LEE SUBDIVISION

APPLICATION NUMBER 11 DATE July 1, 2004

REQUEST Subdivision

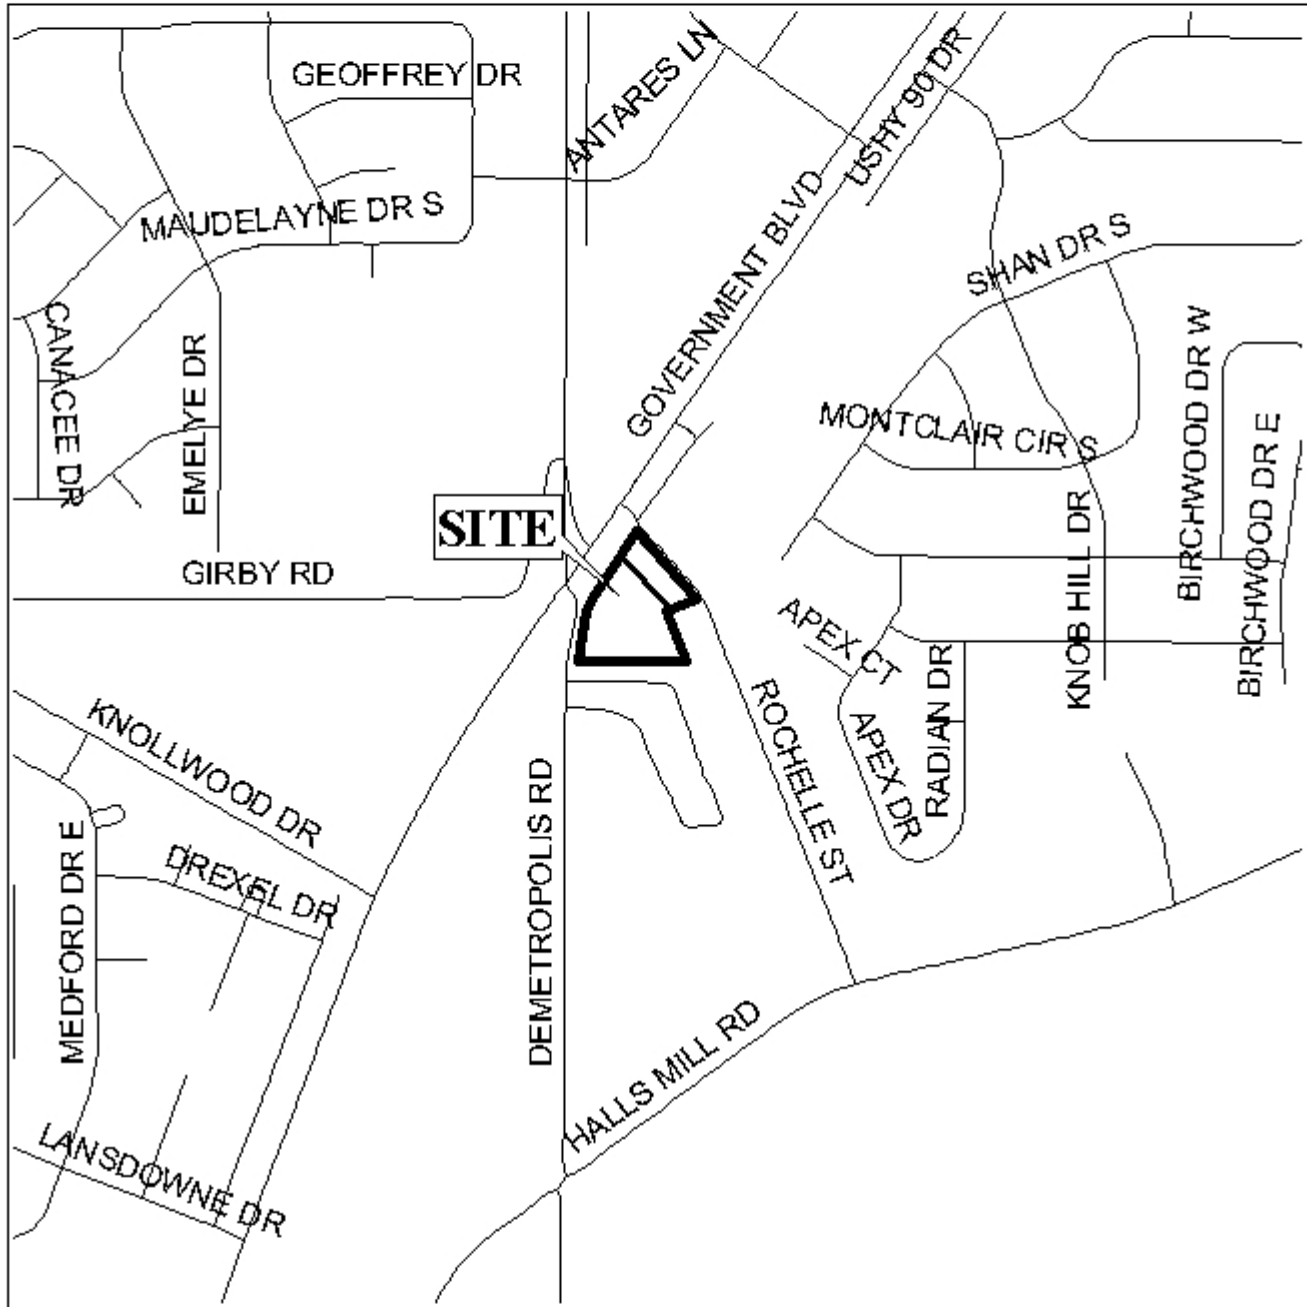
The plat illustrates the proposed 2 lot, 4.0 \pm acres subdivision which is located at the Southwest corner of Government Boulevard and Rochelle Street, extending to the East side of Demetropolis Road and is in City Council District 2. The subdivision is served by public water and sanitary sewer.

The site fronts Government Boulevard, a planned major street and has an existing right-of-way in compliance with the Major Street Plan. Also, the site fronts Demetropolis Road, a planned major street which is illustrated on the Major Street Plan, and has an existing right-of-way of 80 feet, thus the dedication of sufficient right-of-way to provide 50-feet from the centerline would be required.

Additionally, access management is critical since the site is a corner lot at the intersection of two Major Streets, therefore, a note should be placed on the final plat stating that the number, location and design of all curb cuts should be approved by ALDOT and Traffic Engineering.

The plat meets the minimum requirements of the Subdivision Regulations and is recommended for Tentative Approval subject to the following conditions: 1) dedication of the necessary right-of-way to provide 50-feet from the centerline of Demetropolis Road, a planned major street; 2) the placement of a note on the final plat stating that the number, location and design of all curb cuts to be approved by ALDOT and Traffic Engineering; and 3) the placement of a note on the final plat stating that any work on or under the two Live Oaks (80" and 40") in the northeast corner and also the 48" Red Oak in the southwest corner is to be permitted and coordinated with Urban Forestry; removal to be permitted only in the case of disease or impending danger.
